Re: Project Modification – South Fork Export Cable (SFEC-OCS) Micrositing Adjustment

Project Modification Summary
SFEC-OCS Micrositing Adjustment

Project Modification Summary
SFEC-OCS Micrositing Adjustment
Supplemental Information
Submitted to BOEM on May 11, 2022

**South Fork Wind Farm Project
Project Modification Summary: SFEC-OCS Micrositing Adjustment
Supplemental Information
May 11, 2022**

Attachment A: Project Location Figure

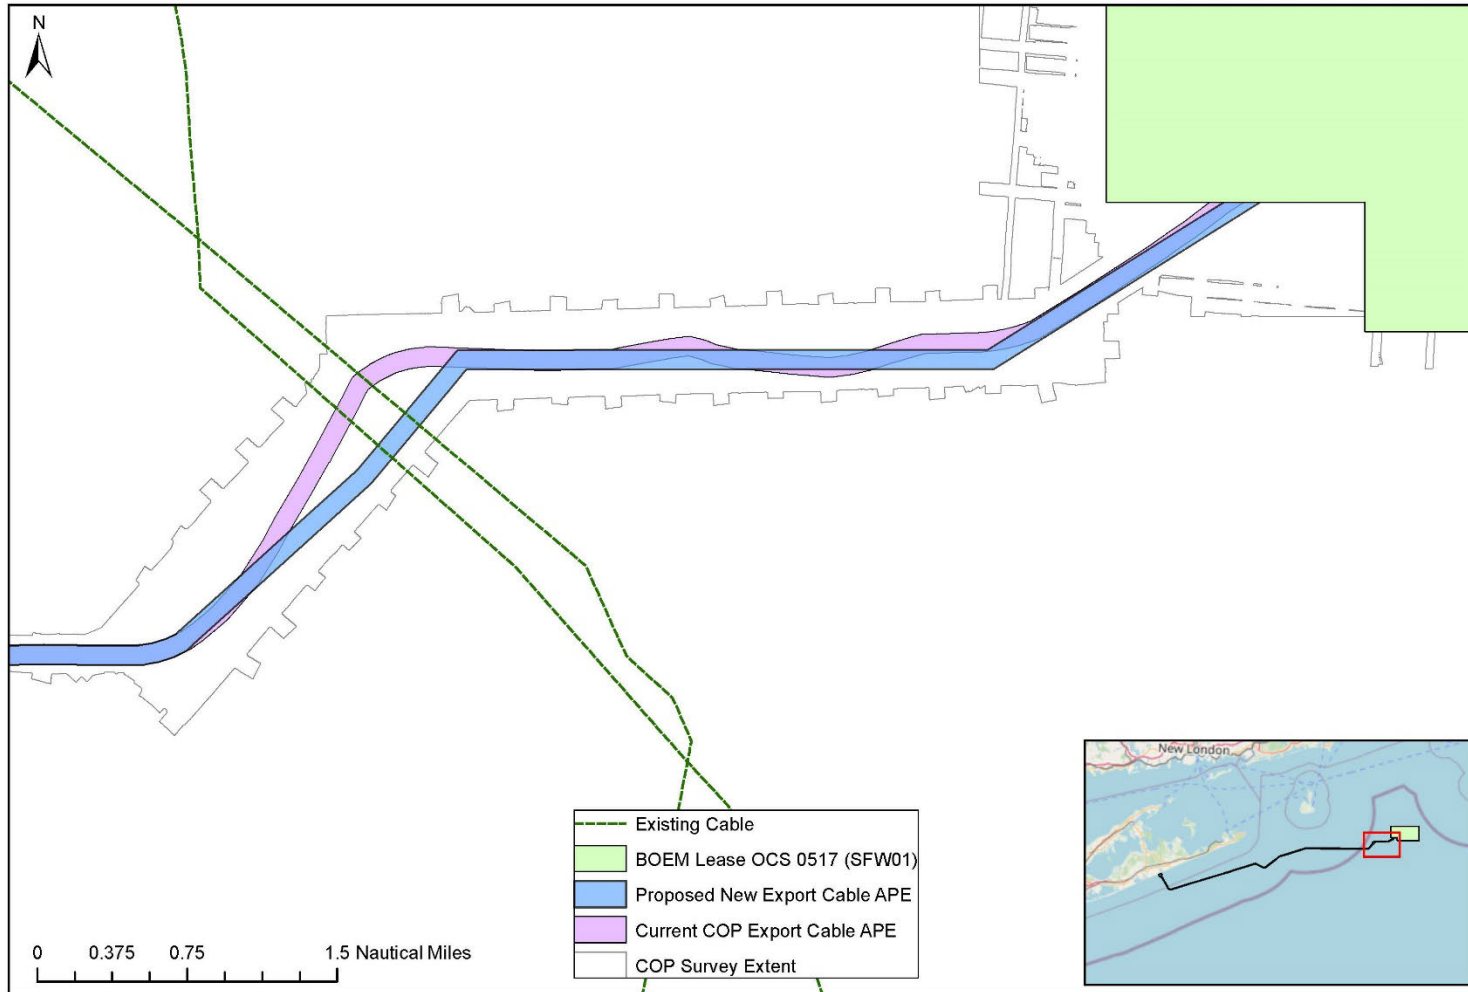
Attachment A depicts the area requested for the microsited SFEC-OCS route. The micrositing adjustment for the SFEC-OCS route is, at the maximum 1318 feet (402 meters) from the current easement. Attachment B provides the specific coordinates that SFW requests be amended from the easement request submitted to BOEM on October 18, 2021.
